## Attachment 4

**IN RE:** Michigan Potash & Salt Co.'s applications to modify UIC permit numbers: MI-133-11-0004, MI-133-11-0005 and MI-133-11-0006.

Figure 1

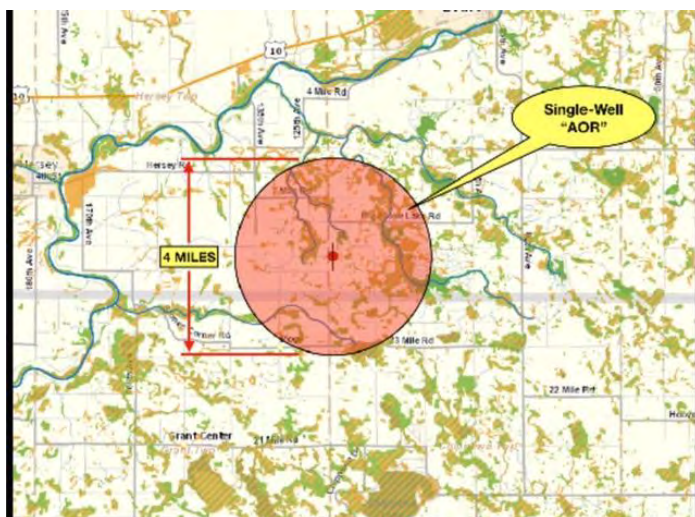
**1. The "Combined" Area of Review (AOR) appears to rely on flawed assumptions:**

The overall "combined" project AOR consists of three overlapping four mile diameter AOR circles, one around each of the three proposed disposal wells. [See Figures 1, 2 below]. Those circles represent the maximum distance injected brines are presumed to migrate under pressure, during the operational life of each well. The underlying modeling used in setting the combined AOR appears to assume that incompressible fluid (i.e. salt brine) injected into each well will not interact dynamically with brines injected at high pressure from other wells. [See Figure 2, below]. But, at the 1,006-psi maximum pressure proposed, physics and common sense suggest that **these incompressible fluids will push against each other, distorting and expanding outward the perimeter of each well's area of influence.** The two outer wells would push outward to each side (being pushed by pressure from the center well). Similarly, the area influenced by the center well would bulge out from in between those two areas. The overall effect would be to expand the area of the injection zone, well beyond the limits of the area studied by the EPA. [See Figure 3, below].

Figure 4

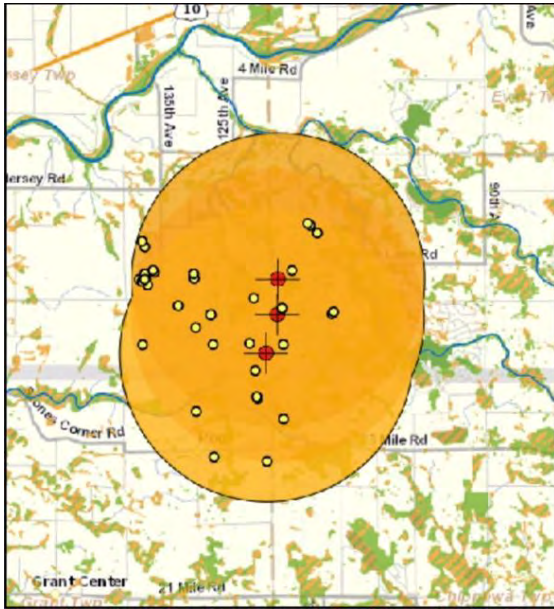
2. **The proposed Combined AOR ignores additional possible breaches in confining layer:** The flawed “combined” AOR has been found to contain upwards of 36 “plugged and abandoned” well-bores that penetrated the original confining layer (Upper Detroit River Group at 4,170’ to 4,962 feet deep) to reach the injection zone (Amherstberg, Sylvania Sandstone, Bois Blanc formation and Bass Island Group at 4,170 to 4,962 feet deep). [See Figure 4]. While historical records (well logs) have purportedly been reviewed for 23 of these bore-holes, suggesting that they were properly plugged, no physical integrity testing has been conducted. Each of these bore-holes is a potential conduit for upward migration of high-pressure injected brines and constitutes a threat to potable water aquifers above. Those aquifers are the sole sources of potable water for the many farms and residences within the AOR. The threat of upward fluid migration is exacerbated by the presence of at least 17 additional abandoned bore-holes penetrating the original confining layer (Upper Detroit River Group - 4,170’ to 4,962 feet deep ) that would fall within an expanded combined AOR if fluid incompressibility were properly taken into account. It is unknown if any of these have been reviewed or evaluated to determine if they were properly plugged. Also, with the top of the injection zone now proposed to move upward 1,000 feet to include the Dundee and Lucas formations, many more abandoned bore-holes may exist that did not penetrate the original confining layer, but do penetrate the new (Bell Shale 3,889 to 3,942 feet deep). These will require review and evaluation to determine their integrity.
